MEMORANDUM

SUBJECT: Austin Waldorf School SER #3800

Austin Waldorf School Wastewater Service Extension Request #3800

**Briefing to the Environmental Commission
June 15, 2016**

**STAFF PROPOSED
APPROXIMATELY
155 FEET OF 8-INCH
WASTEWATER MAIN**

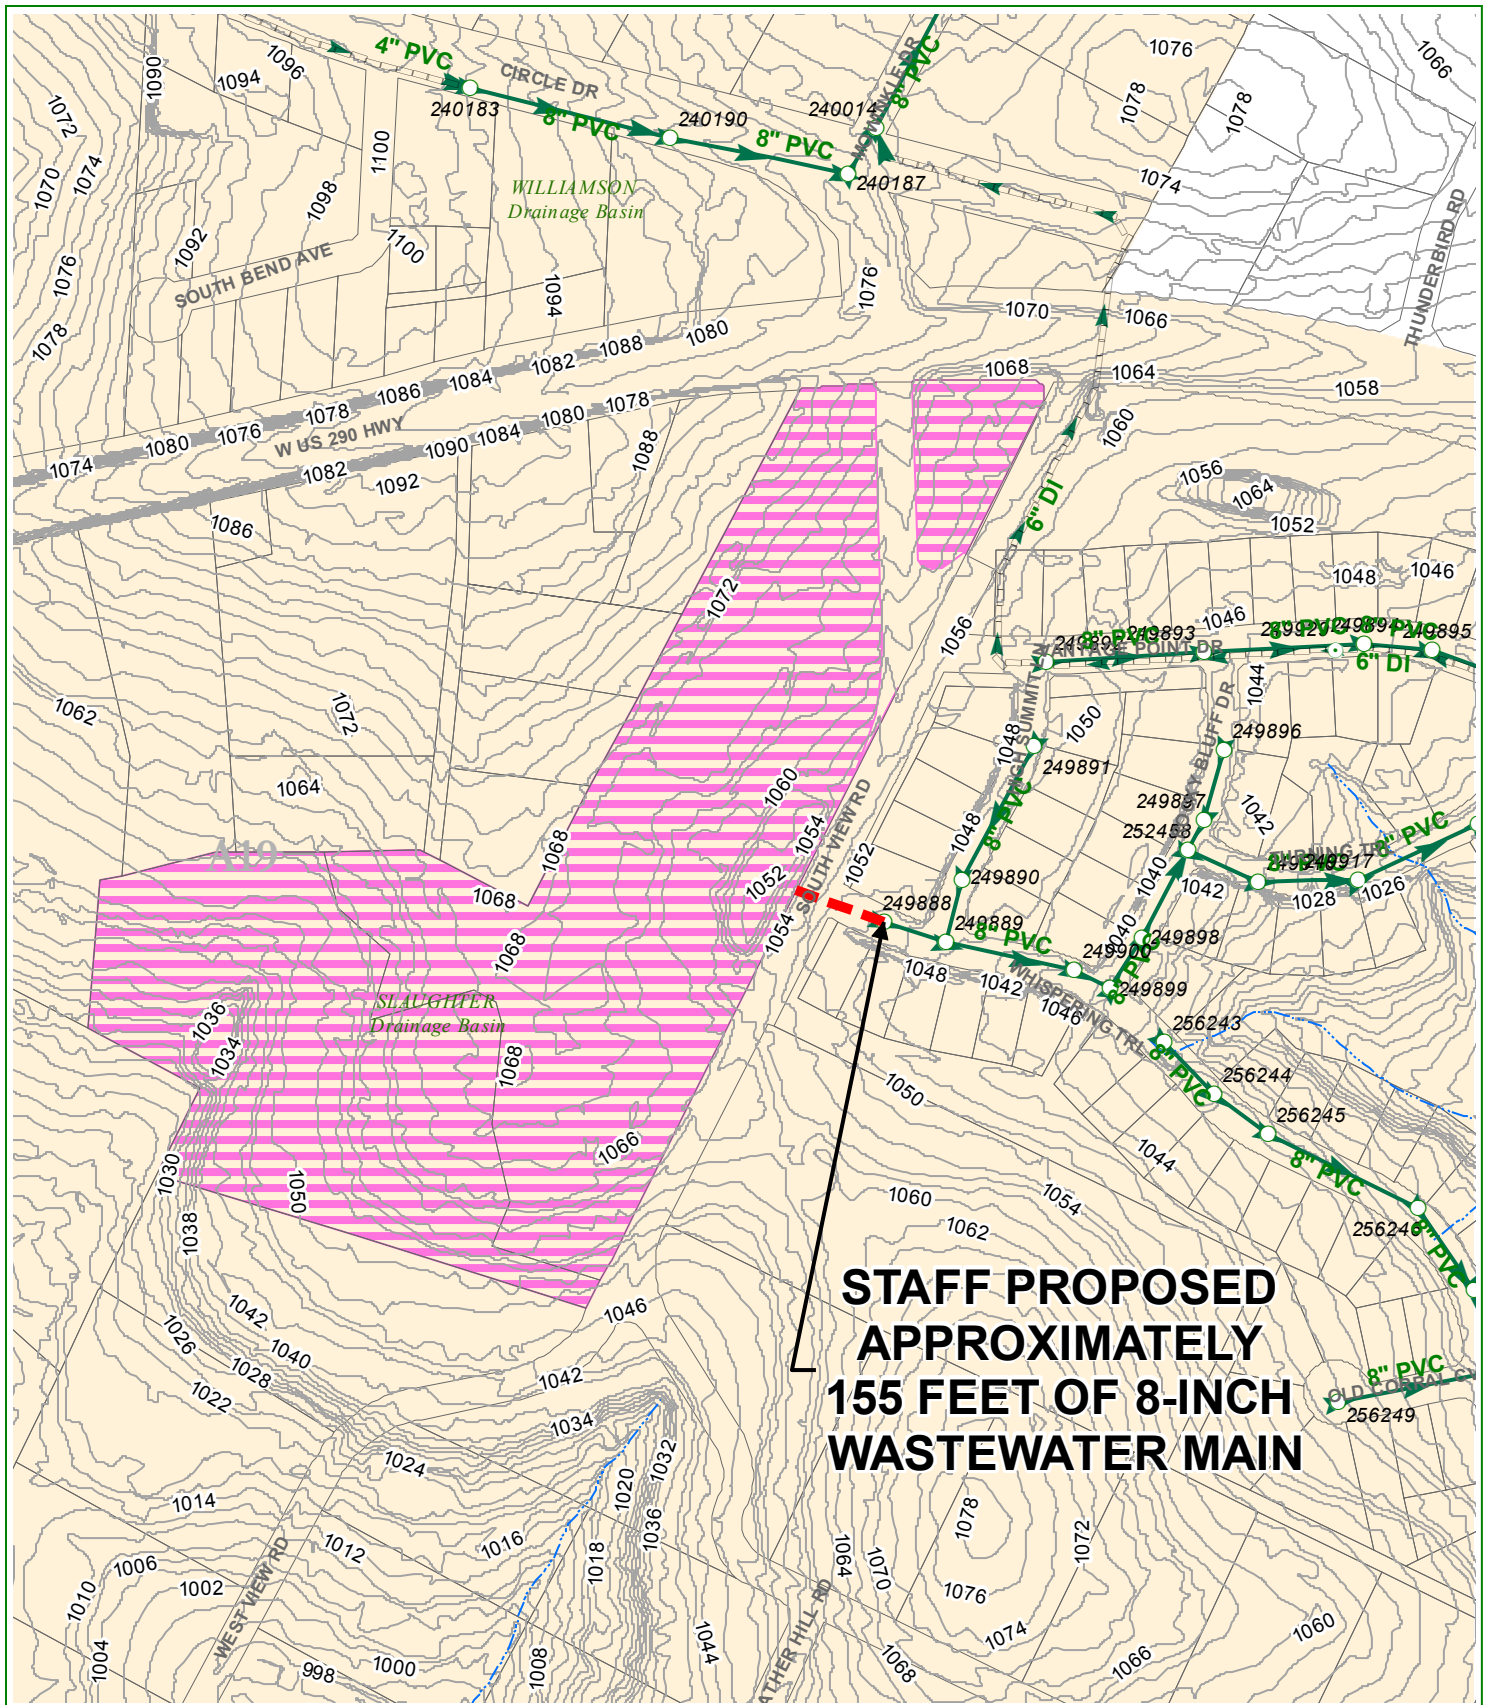
Applicant shall construct approximately 155 feet of 8-inch gravity wastewater main from the existing 8-inch gravity wastewater main (Project No. 2011-0711; MH ID No. 249888) in WHISPERING TRAIL west along WHISPERING TRAIL across SOUTH VIEW RD to the subject tract as shown on the attached map.

Council-Approved Wastewater SERs In Vicinity

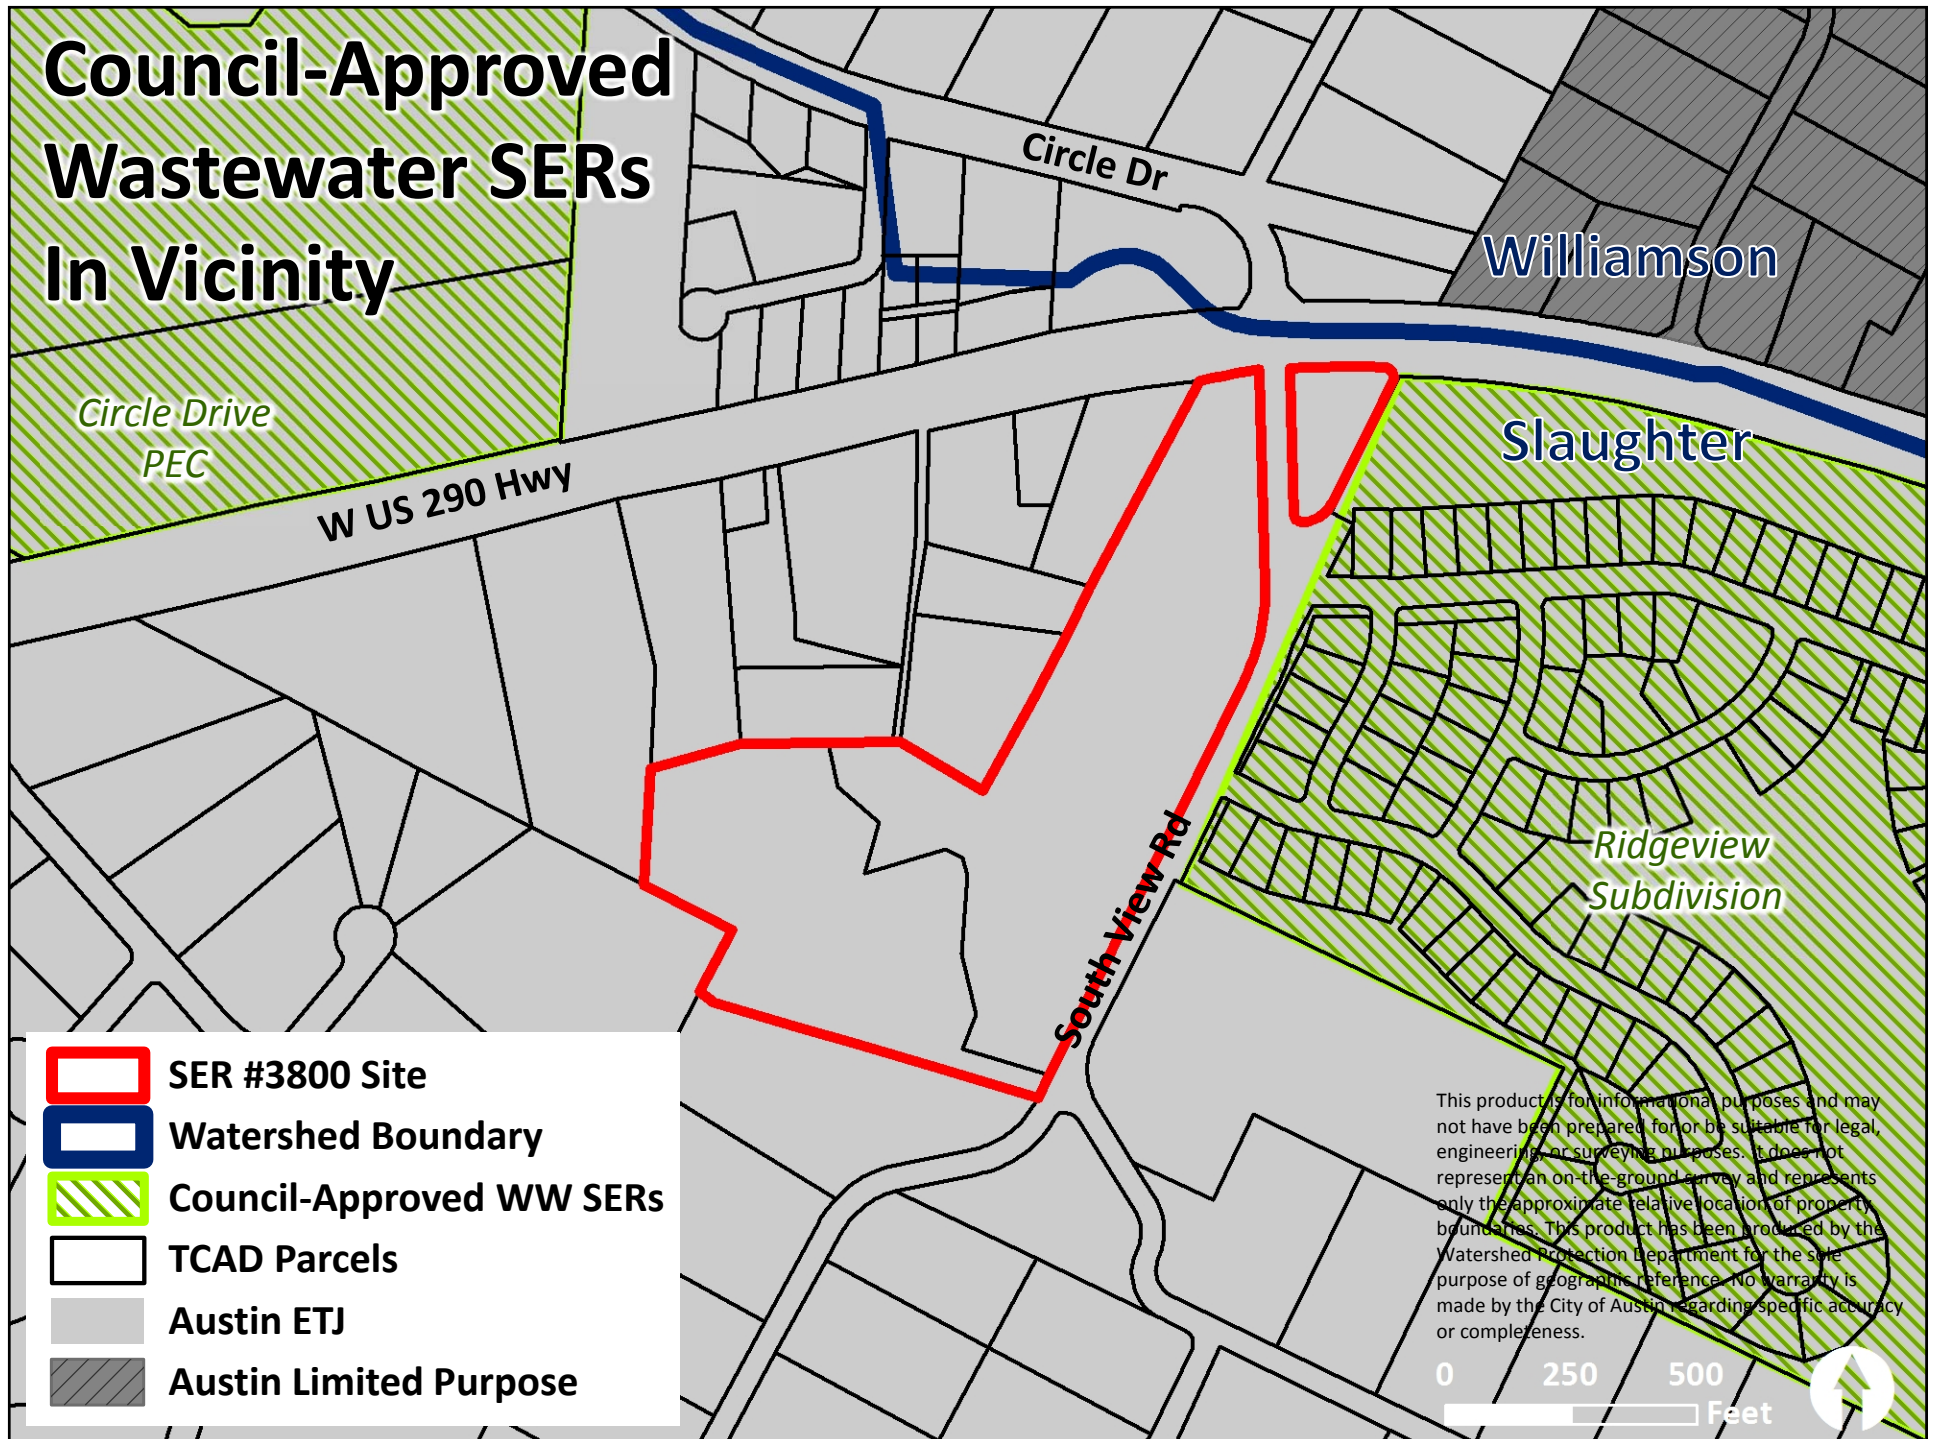
Have similar SERs been granted in the vicinity?

Yes. Council approved a wastewater SER directly to the east of the site (recommended by WPD).

If so, does this development have any additional potential environmental issues to consider?

No. There are no identified additional potential environmental issues on this site.
